ULNRC- 04558

**DOCKET NUMBER 50-483
CALLAWAY PLANT
UNION ELECTRIC COMPANY
RESPONSE TO REQUEST FOR ADDITIONAL INFORMATION
ON REVISION TO TECHNICAL SPECIFICATION 5.5.9
"STEAM GENERATOR (SG) TUBE SURVEILLANCE PROGRAM"**

**REQUEST FOR ADDITIONAL INFORMATION
REVIEW OF THE CALLAWAY PLANT APPLICATION
FOR REVISION TO TECHNICAL SPECIFICATION 3/4.4
TAC NUMBER: MB1214**

Figure R6-15. EDM Notch Cn30: Sleeve Inner Diameter, 0.012" design depth

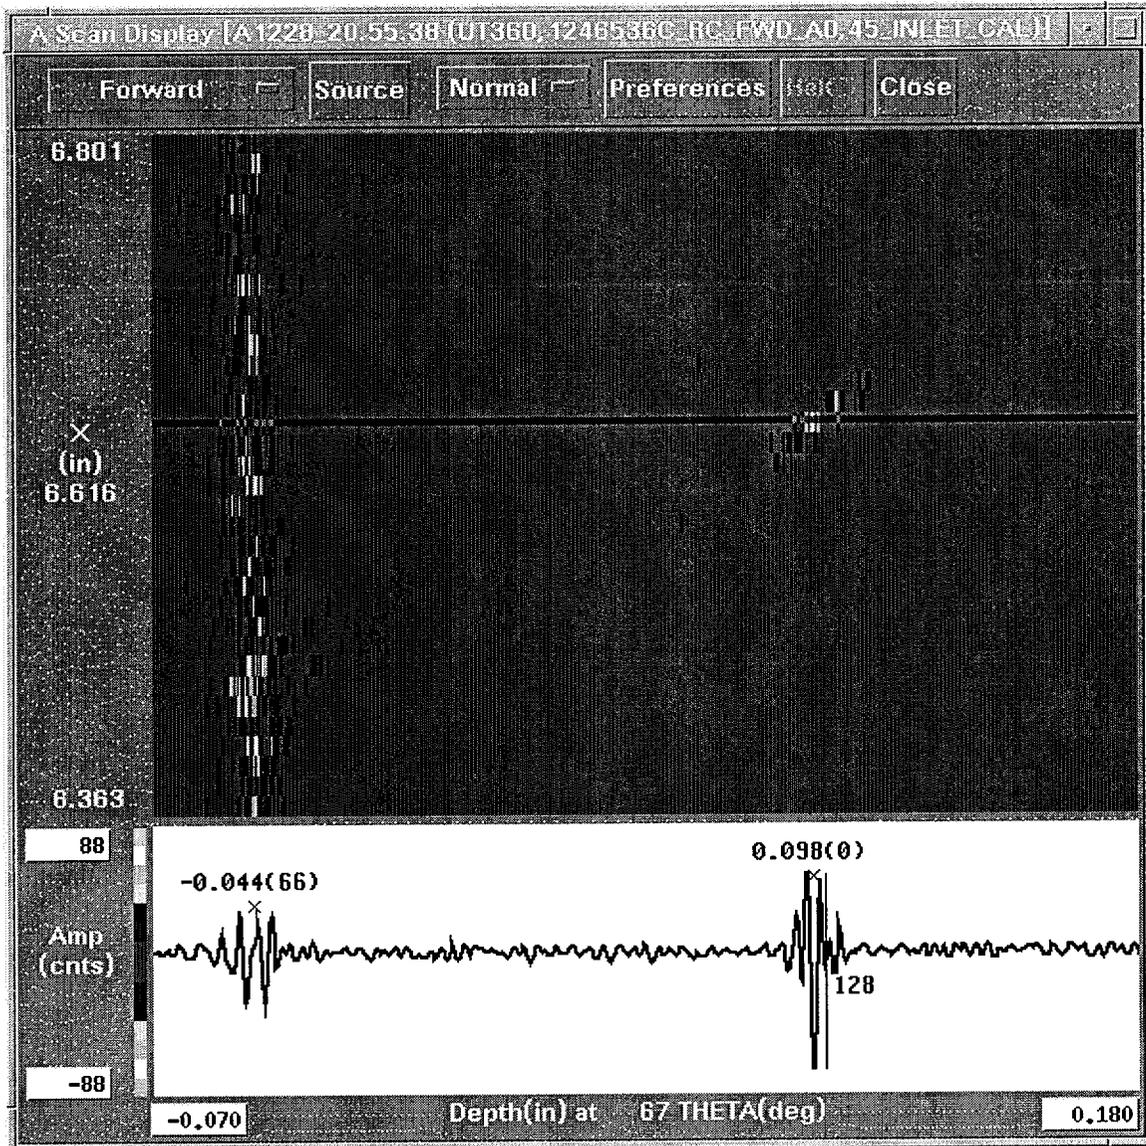
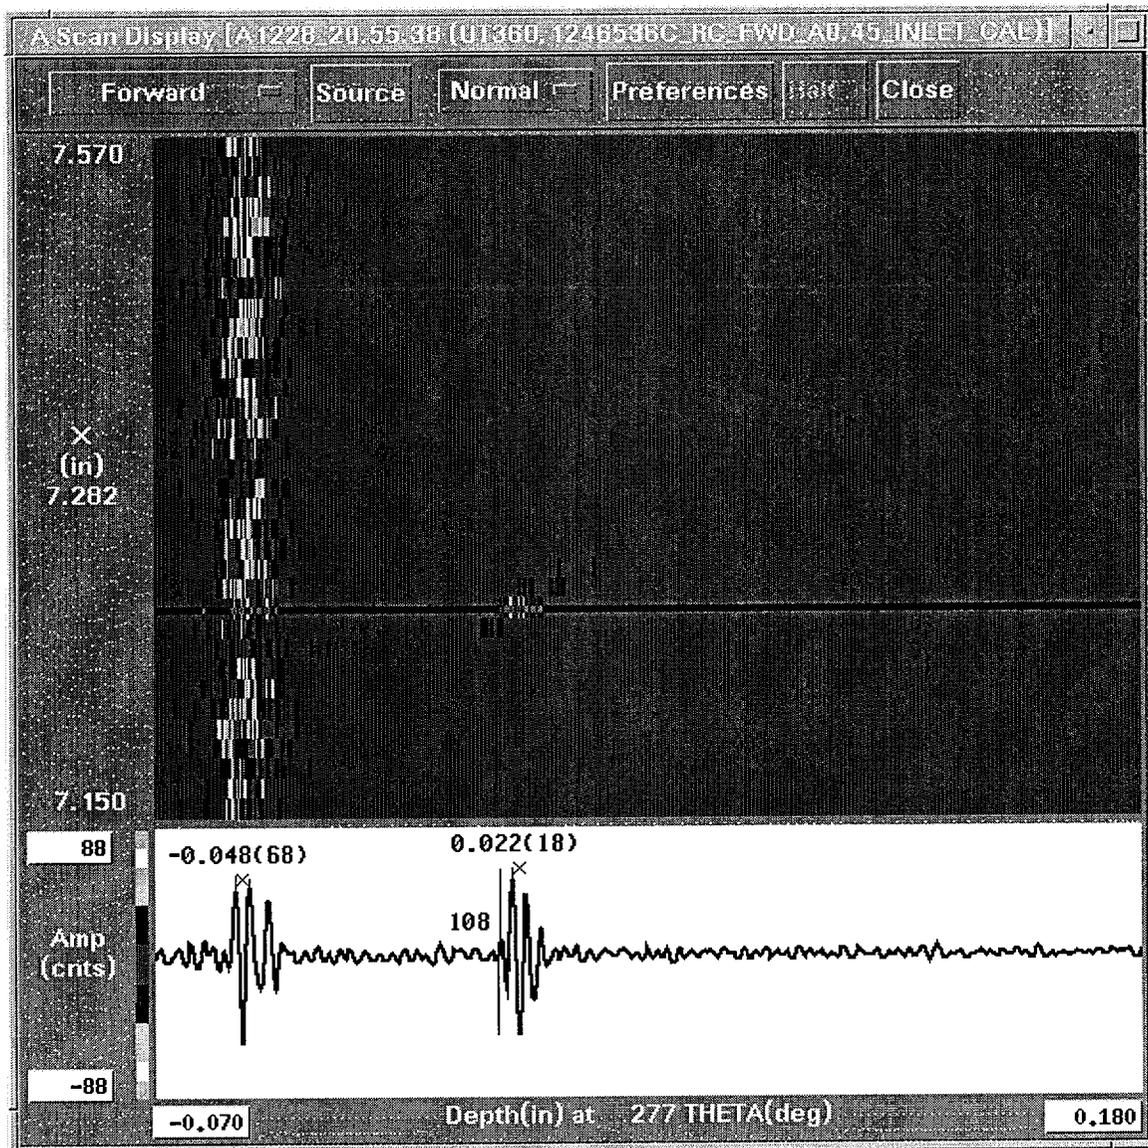
RAI # 6. During the meeting, FTI indicated that PWSCC detectability in the sleeve could be inferred from the ID notches in the UT calibration standards and the data sets containing pits. It is not clear to the staff how detecting EDM notches in the calibration standards or another degradation morphology such as pits would infer an ability to detect tight flaws such as PWSCC. Explain the basis for the statement that sleeve PWSCC ID defects will be detected, and the resulting sensitivity and POD, since the peer review (ETSS # 98404) only covers volumetric defects. Please provide additional discussion or, preferably, additional data to support the claims of the capability of the technique to detect PWSCC in the sleeve. (Question from the 6/7/01 meeting held with UE, FTI, and the NRC staff)

The assertion about the calibration standard and the inner diameter sleeve pit was to demonstrate sensitivity of the ultrasonic technique to inner diameter initiated flaws. The inner diameter pit provides a difficult cross-sectional target due to its cylindrical shape. This was felt to be a more challenging test of the detection capability of the shear wave transducers than the broad side of an EDM notch. The staff is correct in their opinion that neither of these flaws fully represent PWSCC, but these are the only morphologies available for evaluation since sleeve SCC cannot be fabricated.

To support the assertion that the system, (probe and technique) are sensitive to inner diameter flaws, three separate presentations will be offered. The first will show the sensitivity of the system to the inner diameter EDM notches in a calibration standard. The data was acquired in accordance with the

The flaws labeled "Ai" are parent tube inner diameter axial EDM notches. The flaws labeled "Ao" are parent tube outer diameter axial EDM notches. The flaws labeled with the first character "H" are EDM contoured bottom holes. Of interest is the detection of "Ai10", the 0.004 inch deep inner diameter notch.

This is the A-Scan plot showing the inner diameter corner reflection, (full skip) for the notch "Ai10". The notch is at the expected depth for the full skip, (two times the wall thickness) 0.086 inch. The peak to peak amplitude of this reflection is 65 counts out of a possible 256 counts or 25% full screen height.

This is the A-Scan plot showing the inner diameter corner reflection, (full skip) for the notch "Ai30". The peak to peak amplitude of this reflection is 108 counts or 42% full screen height.

This is the axial EDM notch that is used to establish the sensitivity and time-of-flight to depth calibration. The sensitivity must be set between 50% and 80% of the digitizer full scale. For an eight bit digitizer, the full scale is 256 counts (cnts). The amplitude of this reflection is 178 counts or (178/256), 70%.
